**Tennessee Valley Authority
Regulatory Submittal for Kingston Fossil Plant**

Central Area Re-Contouring Work Plan, Revision 5

Stantec White Paper – Dry Ash Stack Subgrade Contouring – July 2010

**Kingston Ash Recovery Project
Central Area Re-Contouring Work Plan, Revision 5**

JACOBS
 CONSULTING ENGINEERS
 TRUCKEE, WYOMING
 CENTRAL WYOMING CELL
 ASBESTOS
 SHEET 2
 DRAWN BY: [Signature]
 DATE: 10/16/01

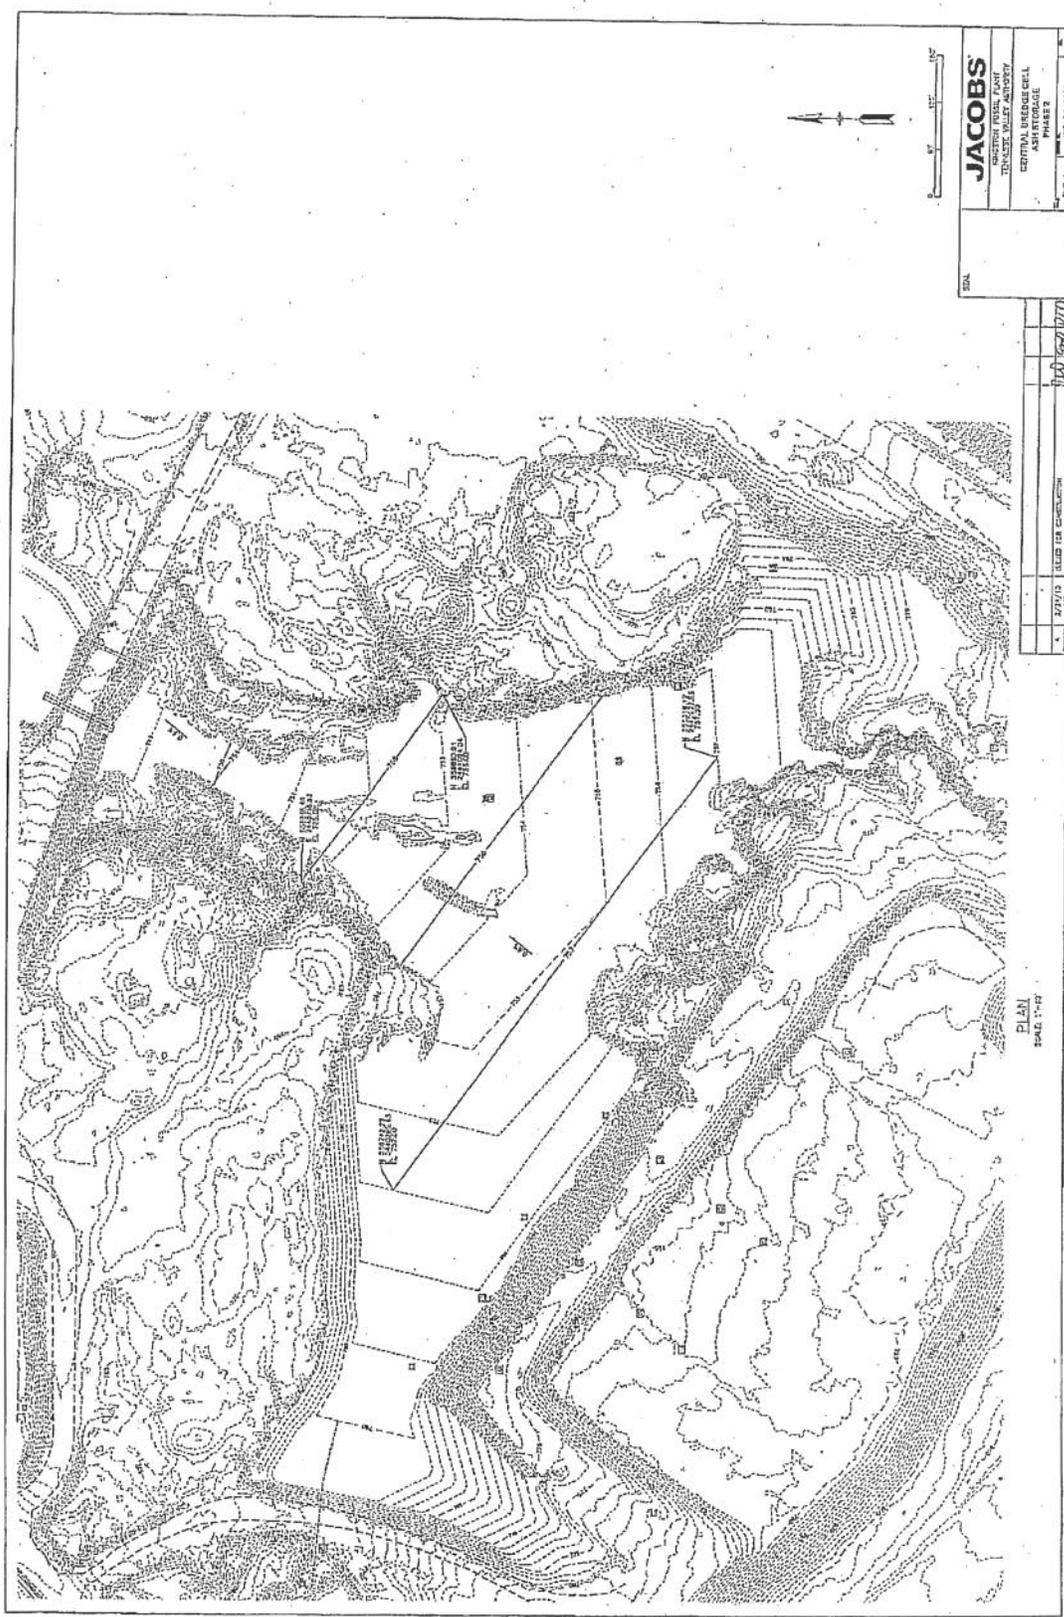
Stantec compared the attached work plan with the current version of our DRAFT subgrade design and it appears that the proposed grading is generally below target working platform elevations. It is noted that the FINAL subgrade design will likely require some degree of cut across proposed fill areas to achieve the desired template. It is recommended that TVA safety professionals evaluate both working conditions at the site and the proposed construction methodology in order to develop appropriate protocols to meet stated objectives outlined in Section 6 of the work plan.

Yes.
